# CITY OF PORTLAND BUILDING PERMIT

210 VALLEY ST

**PERMIT ID:** 2012-65554

has permission to **Buildout basement - Adding two bedrooms**

210 Valley Street  
Flooring diagram

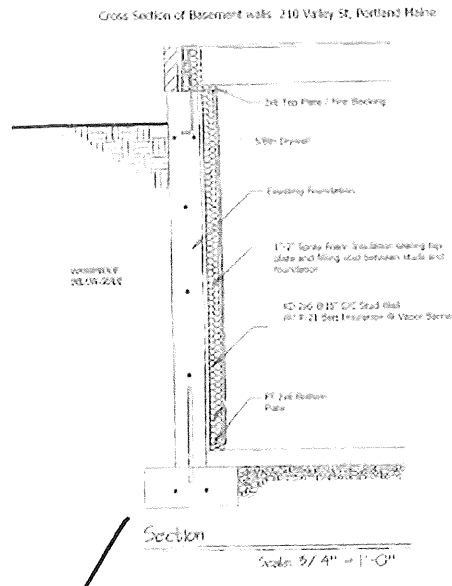
*01/09/13*  
*Proposed slab*  
*4" slab*

# 210 VALLEY ST UNIT 1 additional 2 rooms in basement

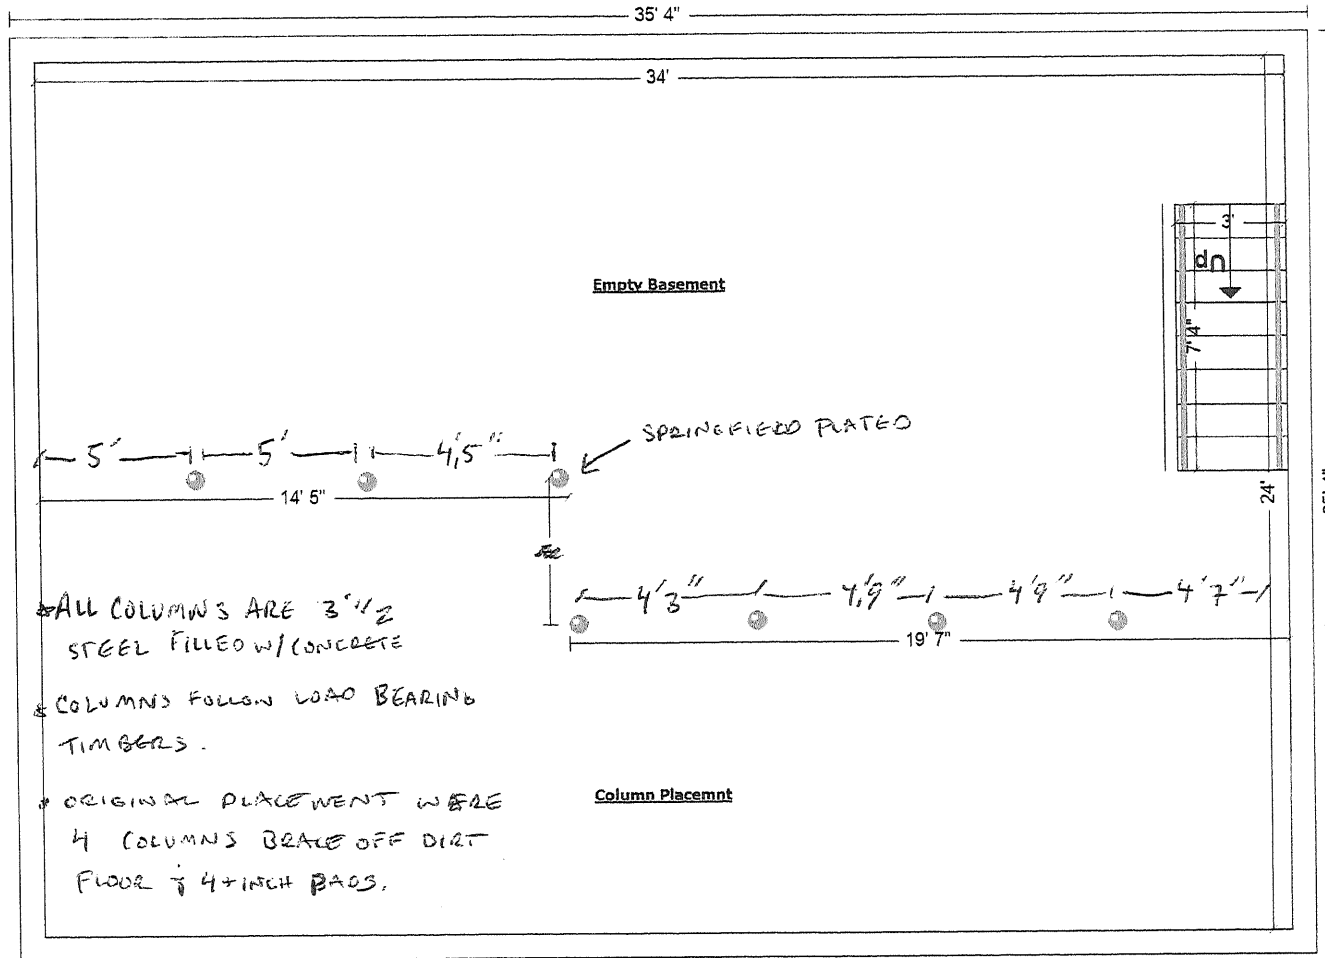
01/14/13  
 "Existing" location added Lally's  
 JGR

Thank you. We did not move anything. This is the layout of the girder system and nothing was moved. A Springfield plate was installed with column were there wasn't any support. Originally there were only 4 post and not one was sufficient for it's intended purpose. My boss who is an engineer decided we need to add more than typical do to the girder system.  
Thanks again. Feel free to call or email with any questions or concerns.

9 Unit 2 bathroom Fire Date Taken: 2/18/2013 Taken By: ANDREW1

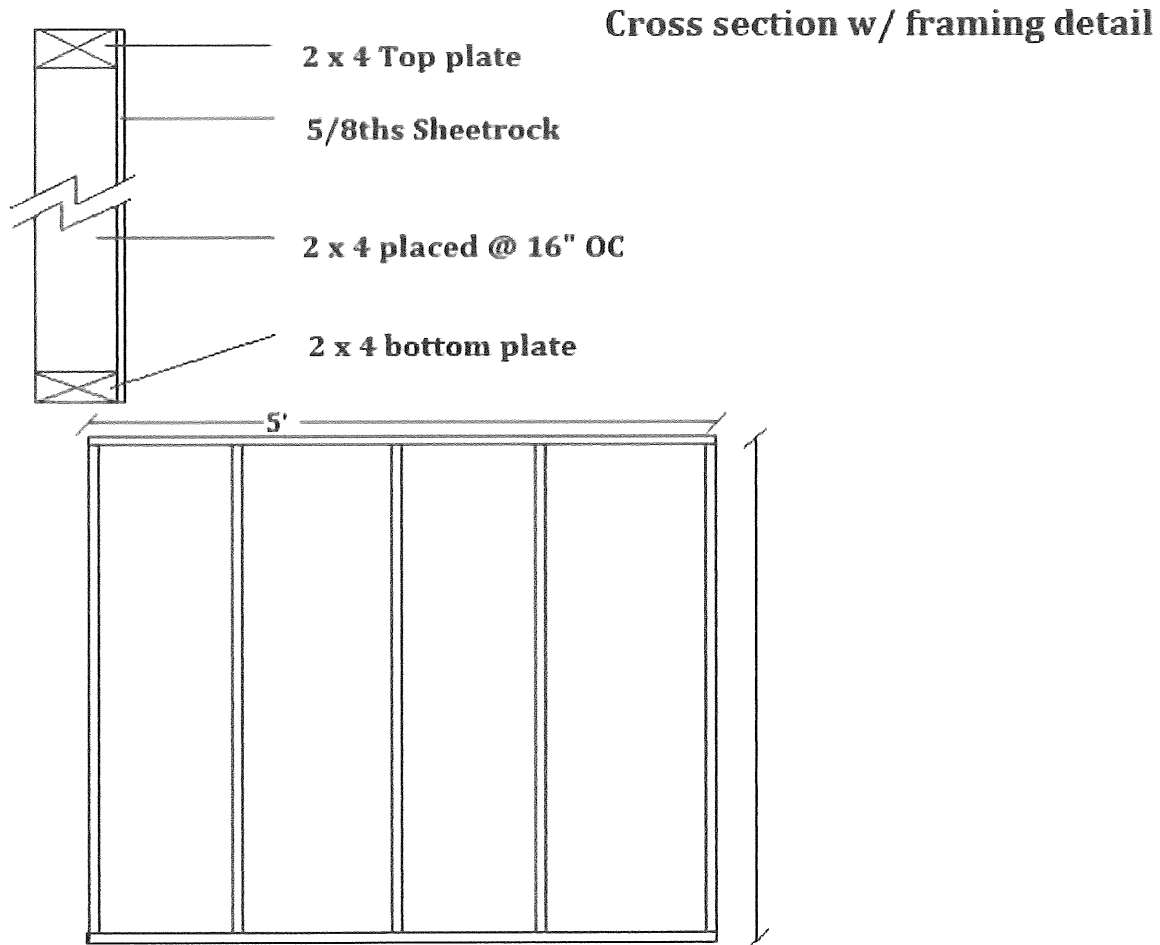
Unit 2 bathroom. After walk through with inspector it was pointed out that these holes needed to be filled with fire rated foam.

13 Bdrm closet Fire foa Date Taken: 2/18/2013 Taken By: ANDREW1

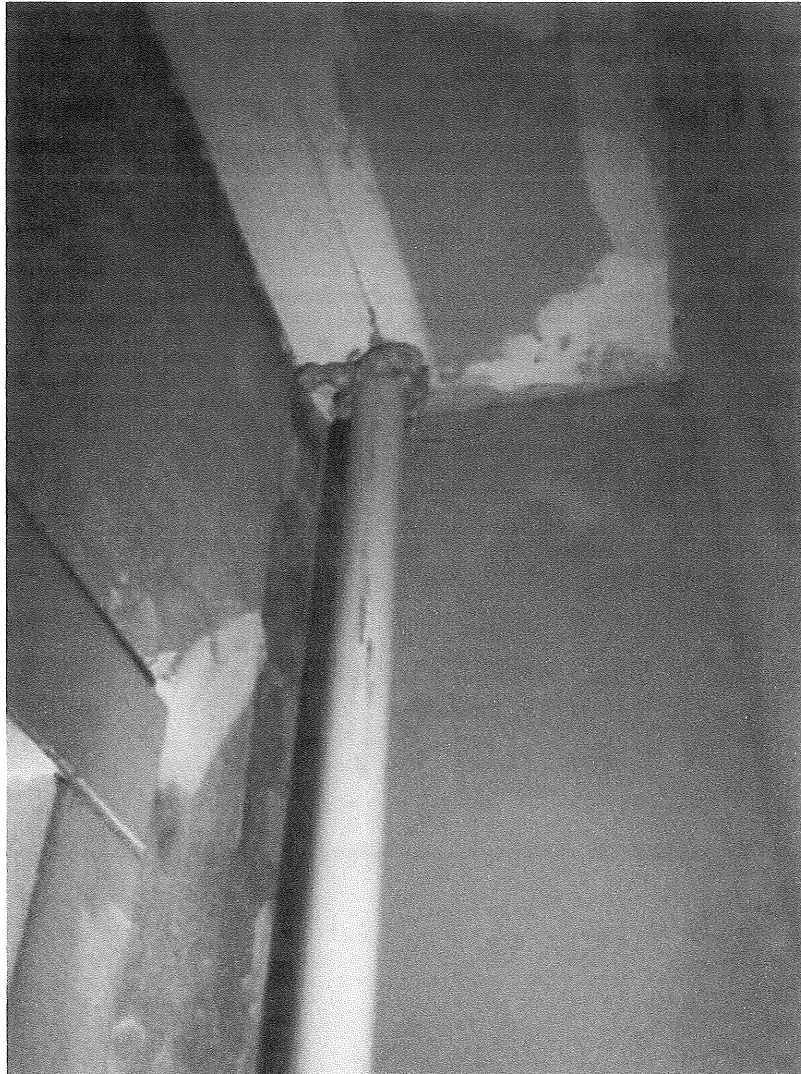
Closet in Unit 2. After walk through with inspector it was pointed out that these holes needed to be filled with fire rated foam.

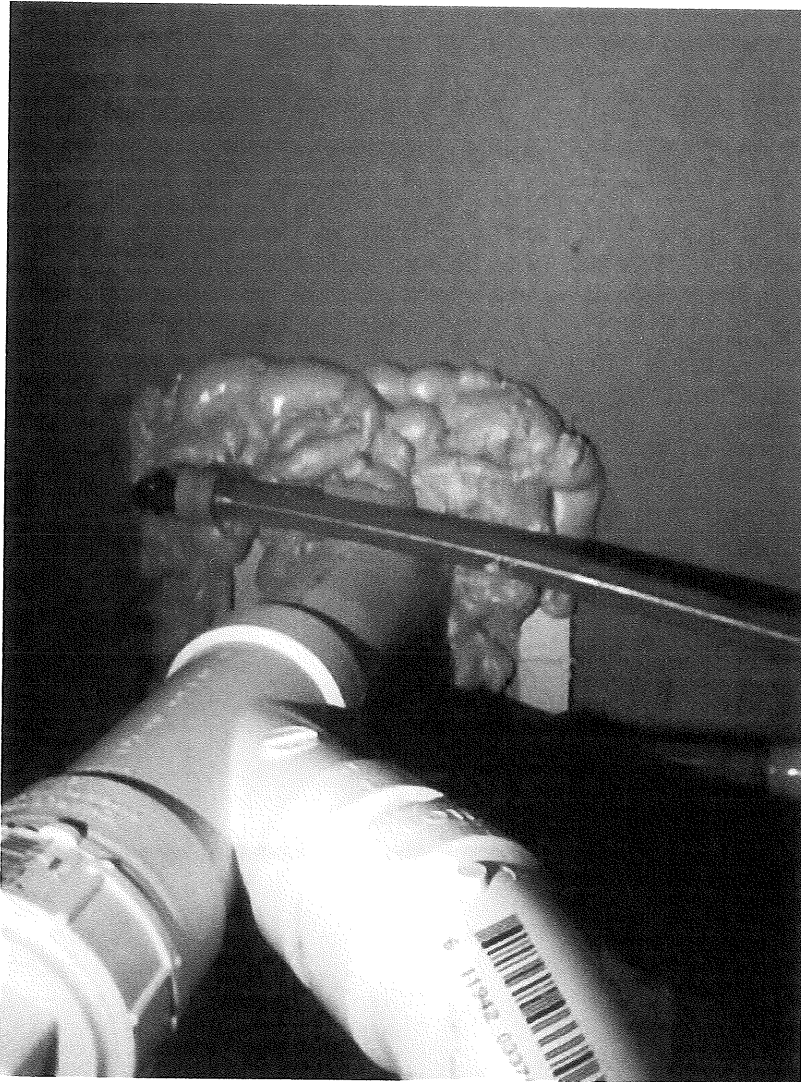
Top of closet in Unit 2. After walk through with inspector it was pointed out that these holes needed to be filled with fire rated foam.
